G190EAN01.0
Engineering Change Notice

2026/03/13

AUO Display+

EC Item 1 - Panel material & structure change

(Current) G190EAN01.0 / 97.19G06.002	(New) G190EAN01.0 / 97.19G06.012

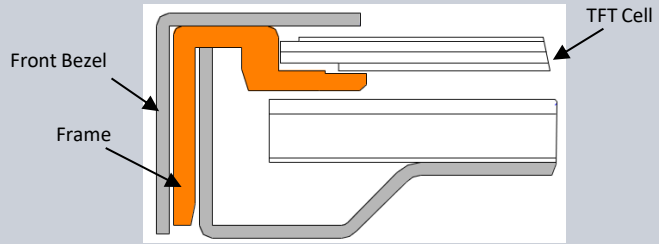
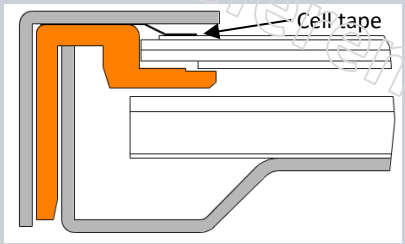
Change Item			(Current) G190EAN01.0 97.19G06.002	(New) G190EAN01.0 97.19G06.012	Remark
OM	Material	DBEF	3M A	3M B	Supply issue
		Diffuser	Lucky	Dimosi	Supplier allocation
		LGP	Printing	Hot-pressing	New design provides better compatibility with hot-pressing.
		Reflector	Toray A	Toray B	Supply issue
	Structure	Cell tape	NA	Cell tape structure	Reinforce the structure to reduce particle intrusion.
		Conduction	Conduction tape	NA	New design doesn't require this tape.

- Cell tape design: Reinforce the structure to reduce particle intrusion.

EC Item 2 - 2D Drawing

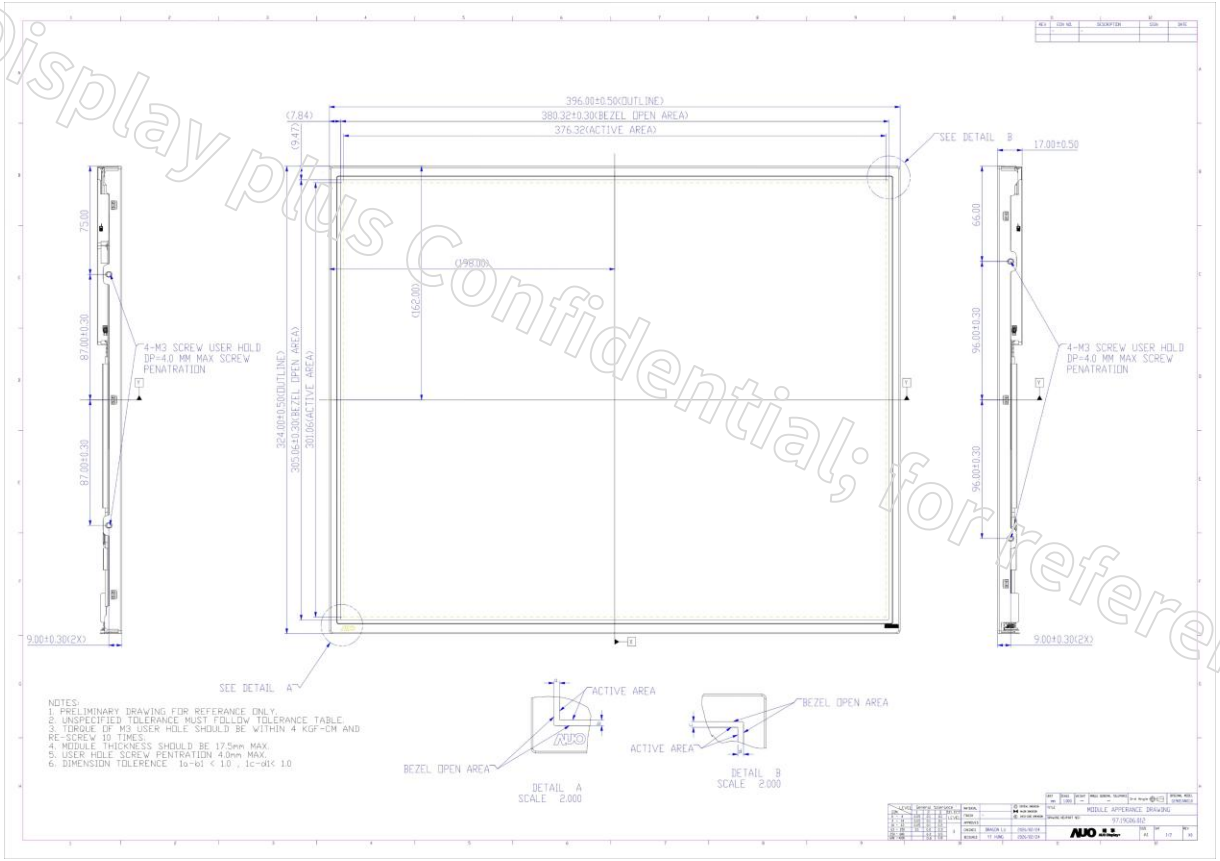
- Front side:

EC Item 2 - 2D Drawing

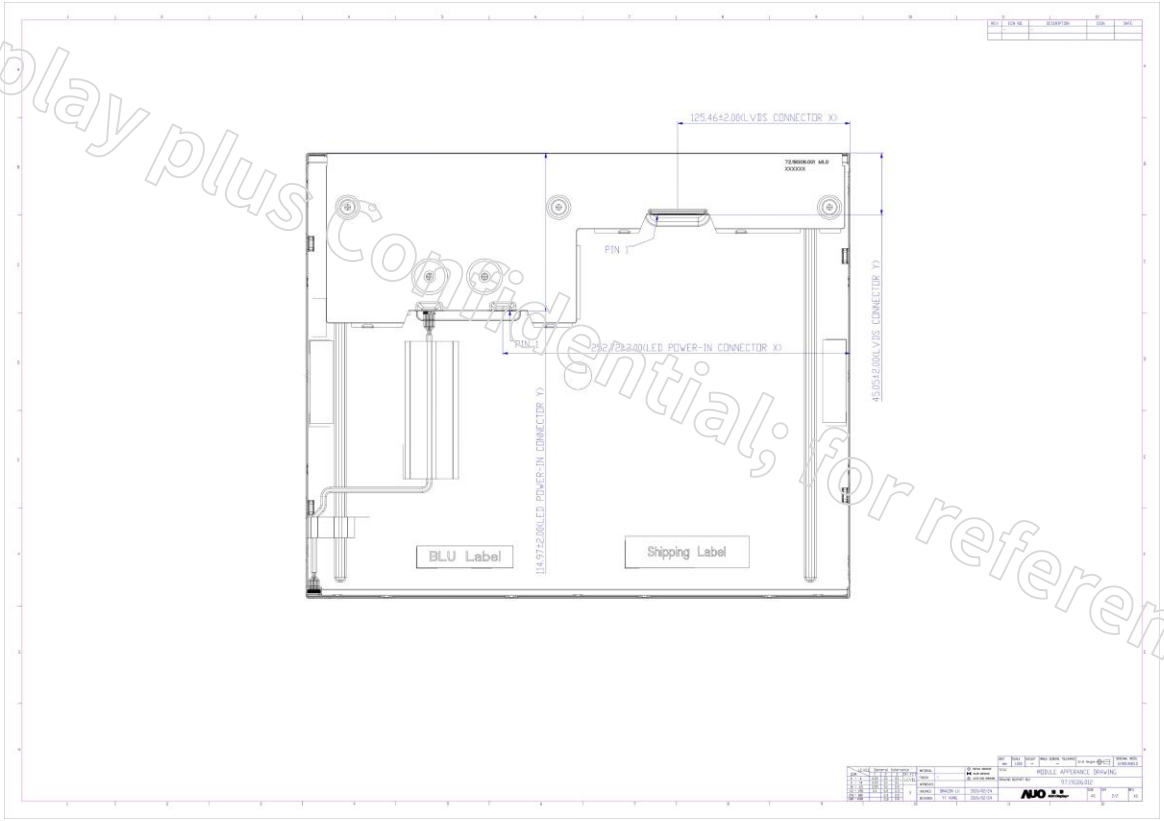
- Back side (remove conduction tape):

EC Item 3 - Label

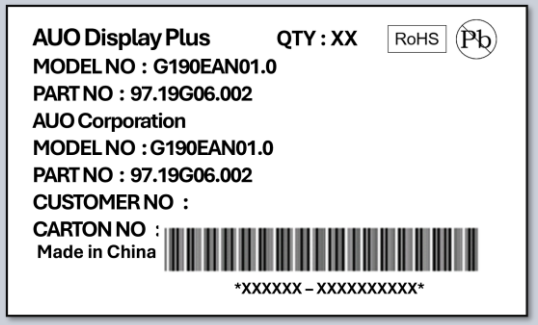
(Current) G190EAN01.0 97.19G06.002	(Replacement) G190EAN01.0 97.19G06.012

- Shipping label & Carton label
